UNITED STATES ENVIRONMENTAL PROTECTION AGENCY
REGION IX
75 Hawthorne Street
San Francisco, CA

Thank you for providing for review the *Draft Work Plan, Radiological Survey and Sampling*, Former Hunters Point Naval Shipyard, San Francisco, California ("Work Plan"), February 2018. The U.S. Environmental Protection Agency (EPA) reviewed this report in detail with a technical team including national experts in health physics, geology, and statistics.

EPA Review of the Draft Work Plan Radiological Survey and Sampling Former Hunters Point Naval Shipyard, San Francisco, California, February 2018

STATISTICAL REVIEW OF UNITED STATES NAVY PROPOSED WORK PLAN FOR RADIOLOGICAL SURVEY AND SAMPLING, HUNTERS POINT NAVAL SHIPYARD SITE (HPNS)

Figure 1. Distribution of Ra-226 Off-Site Laboratory Measurements in picocuries per gram (pCi/g) in Background Reference Areas

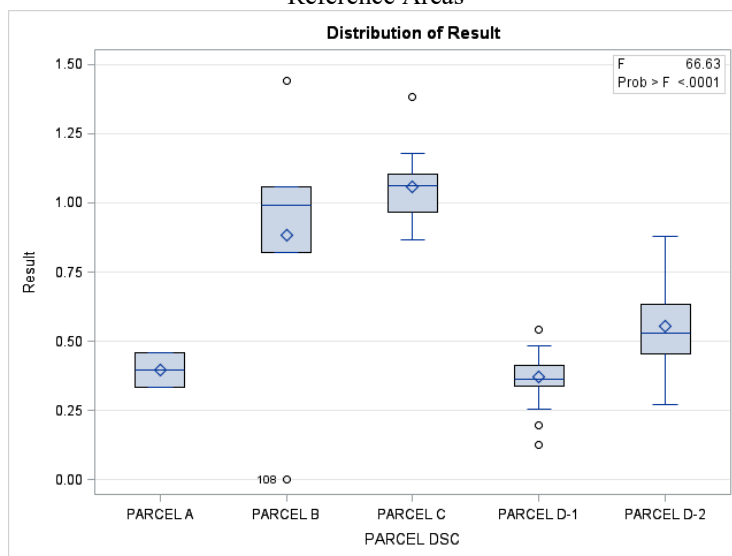
Comment 4: Section 4.2.1 Soil Reference Areas – page 4-14

Reviewer Comments: In order to meet MARSSIM and NRC criteria, sample sizes for background reference areas should be computed per independent interval, surface soils and subsurface soils, not across both. Additionally, it is clear from historical data provided by the Navy and collected at the background reference areas in Parcels A, B, C, D-1, and D-2, that variability is not consistent across the five areas for off-site laboratory Ra-226 measurements (Figure 1).

Recommendations: Given the differences in variability and mean/median concentrations for Ra-226 as demonstrated in Figure 1, it is recommended that background reference area sample data should not be combined across the five areas, but rather background reference areas should be established per Parcel with sample sizes computed based on the variability within each background reference area per independent interval (surface soils and subsurface soils).

Sample sizes should be justified with detailed statistical analyses and explanations of how inputs to the computations were derived, including specifics of how estimates of variability were obtained (e.g., what data was included in the calculation, how and where the data was collected, what assumptions were made). If measurements from multiple background reference areas will be combined, the results of a comparative analysis such as an Analysis of Variance (ANOVA) or non-parametric equivalent (Kruskal-Wallis Test) must be documented to support combining the areas. These comparative tests will establish if there is a statistically significant difference between Ra-226 and Cs-137 in the background reference areas at a specified confidence-level.
